### Proposed Revisions to a Standard Plans Index

Index Number: 639-001

Index Title: SERVICE POINT DETAILS

INDEX	SHEET
639-001	1 of 2

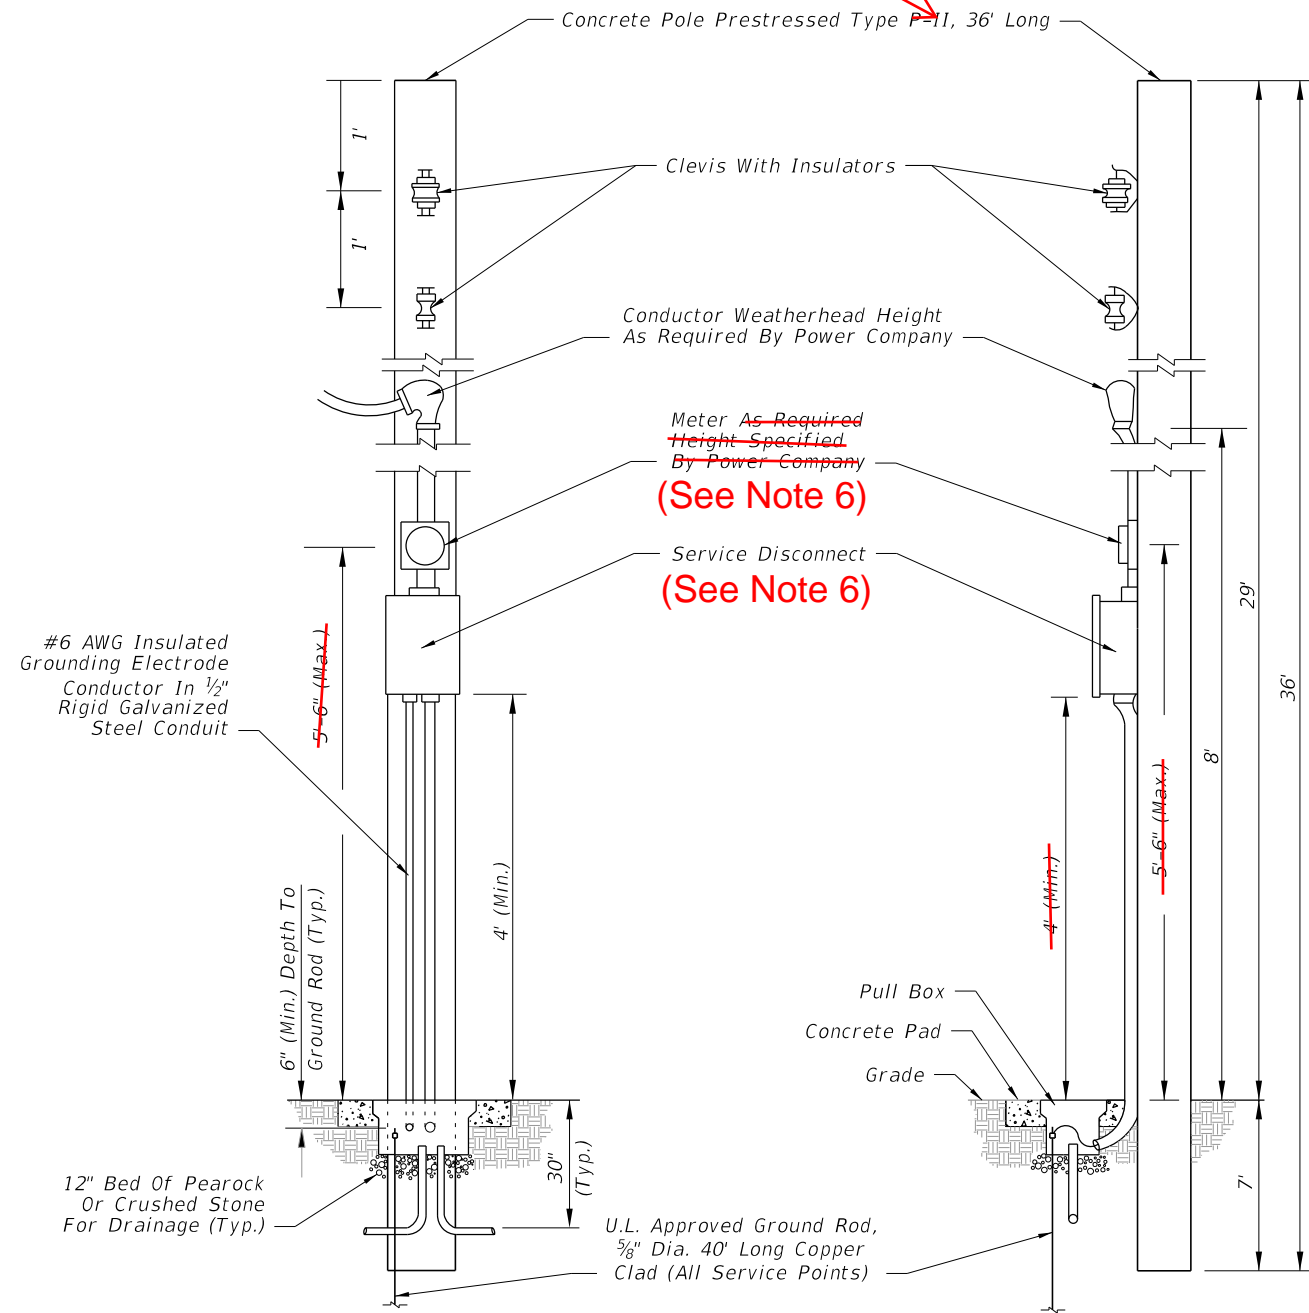
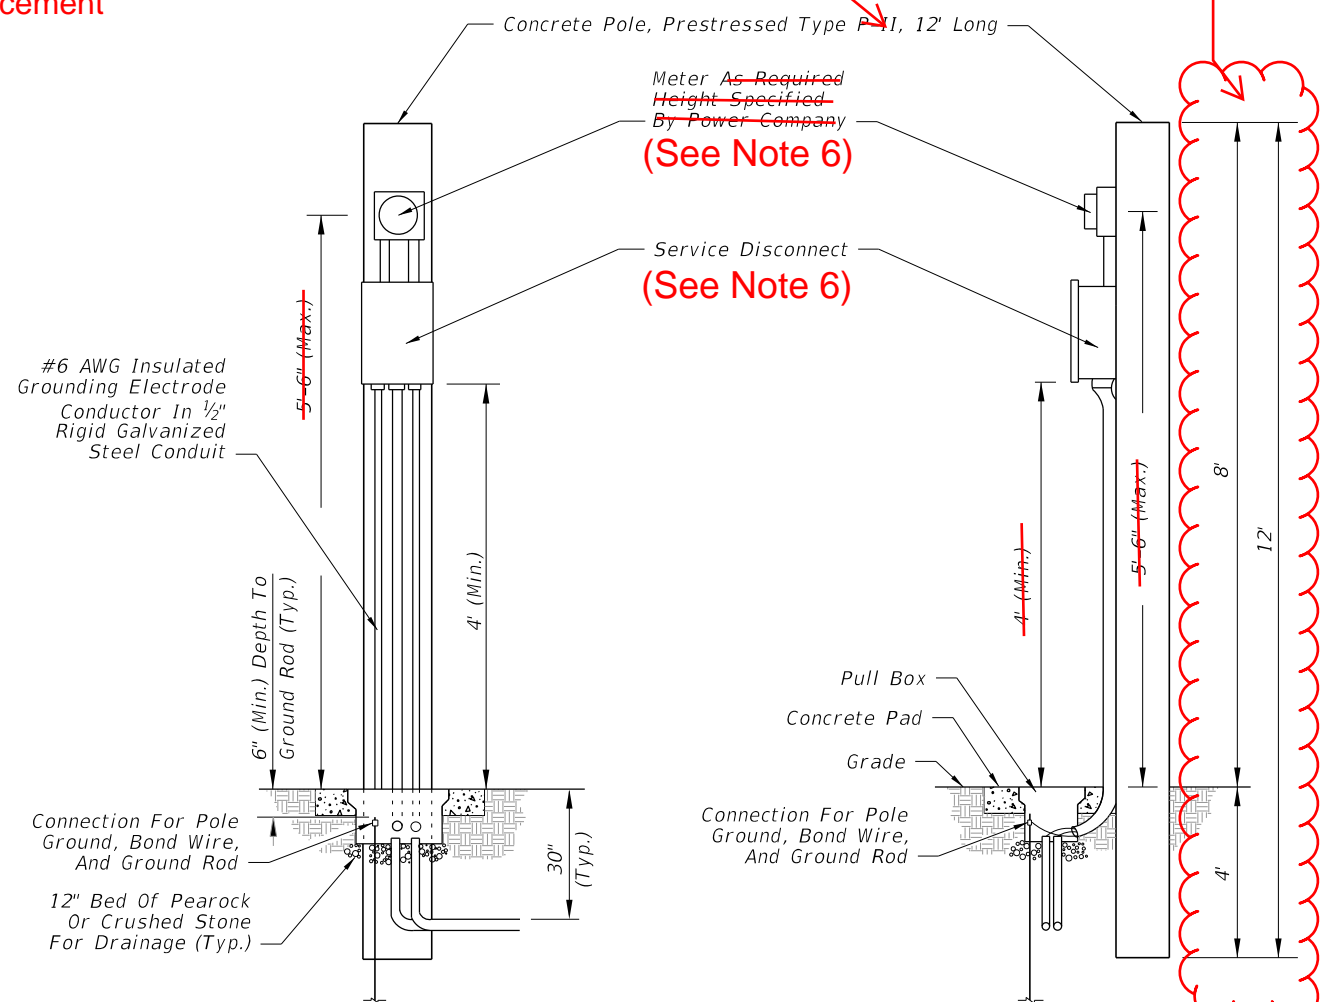
Added pole dimensions for the new Type P-IID concrete pole option in Detail B.

Removed height dimensions for the meter and service disconnect in Details A and B;

Added reference to Note 6 in the meter and service disconnect callouts in Details A and B;

Reworded, added specific "Type P-IIB"

Added note 5 for prestressed concrete pole details and usage

Added note 6 for meter and service disconnect height placement

Reworded, added specific "Type P-IIA & P-IID"

Added dimensions for pole types P-IIA & P-IID

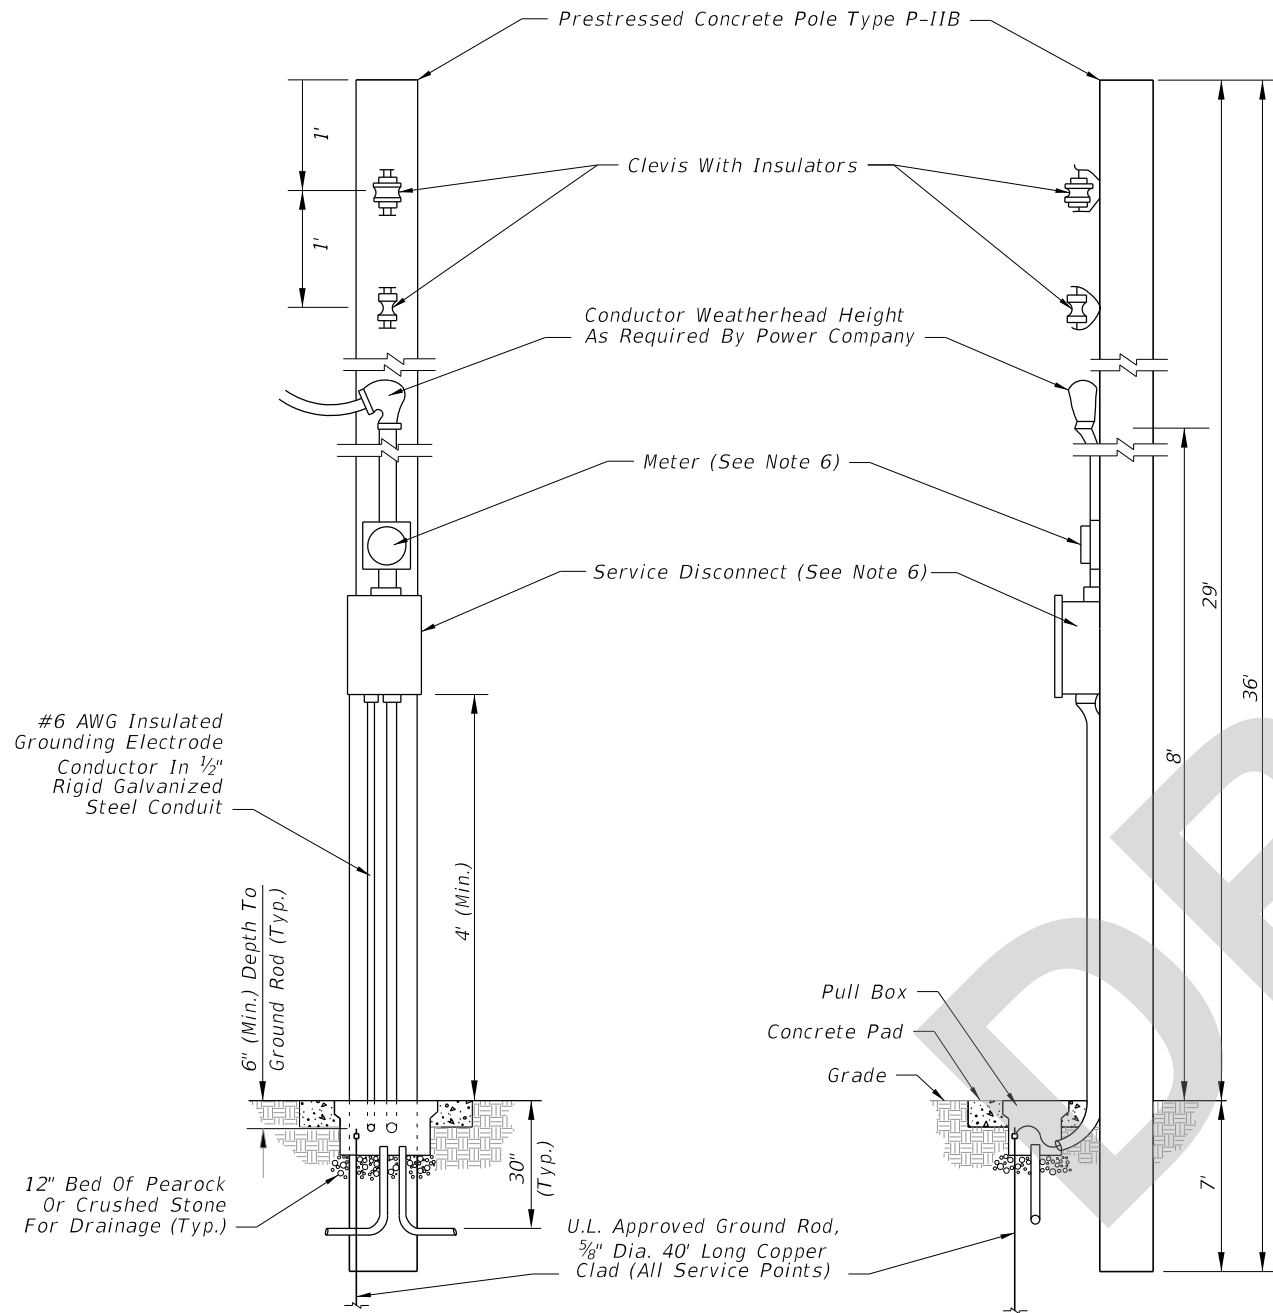
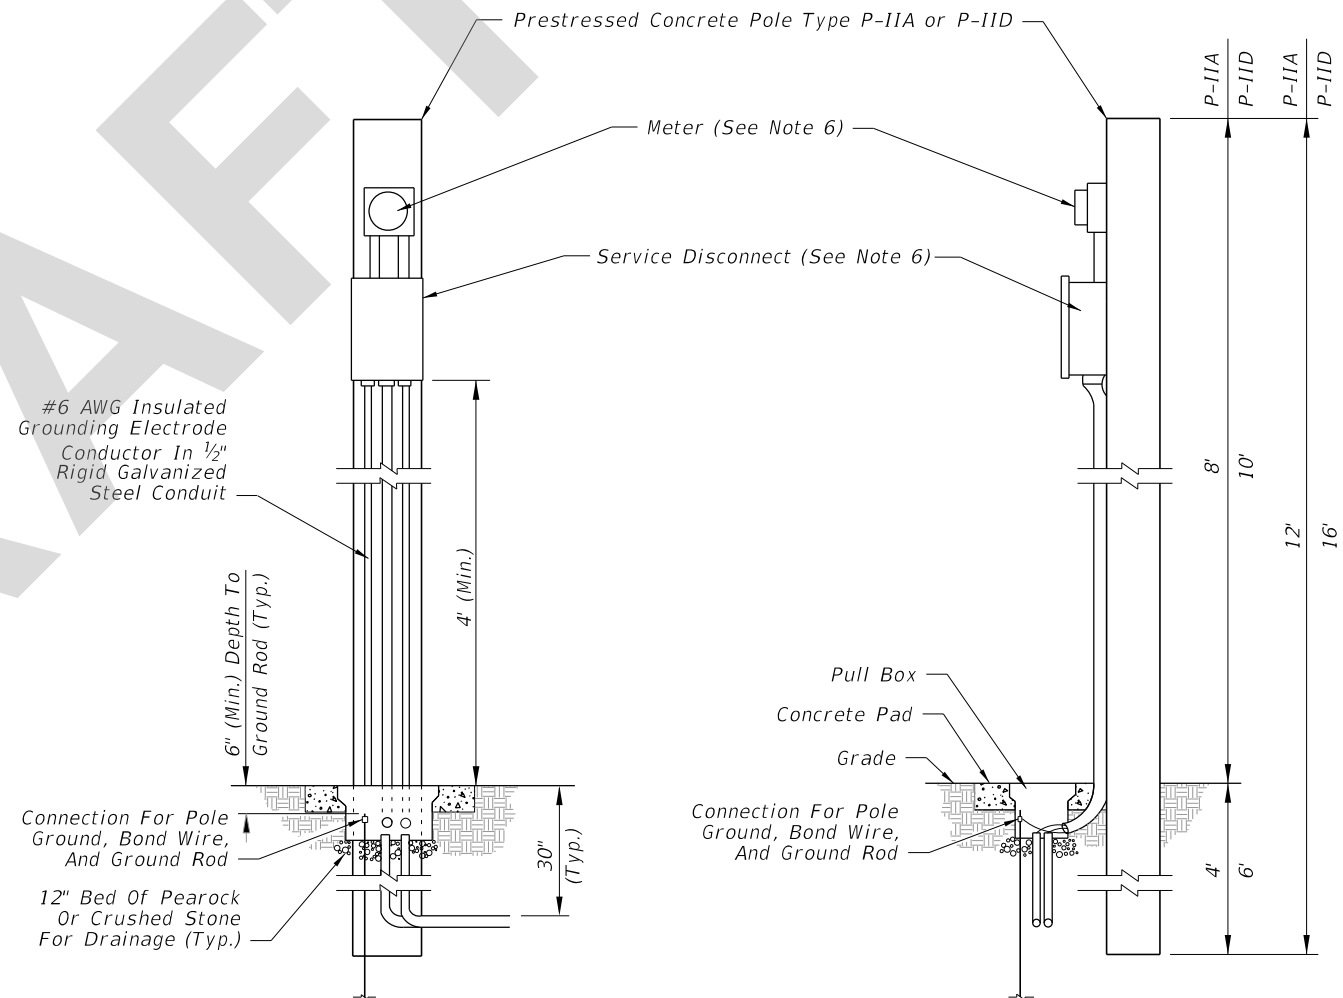
Added Note 5 to reference Index 641-010 for prestressed concrete pole details and explain optional pole usage;

Added Note 6 to provide height information for the meter and service disconnect

1. It shall be the contractors responsibility to provide a complete service assembly as per the plans and service specifications.
2. The service installation shall meet the requirements of the national electric code and applicable local codes.
3. Shop drawings are not required for service equipment, unless noted in the plans.
4. A pull box is required at each service point; see Index 635-001.
5. For prestressed concrete pole details, see Index 641-010. Use the service pole type called for in the Plans.
6. Place the meter and service disconnect at the height shown in the Plans or as required by the power company. The service disconnect may be placed above the meter.
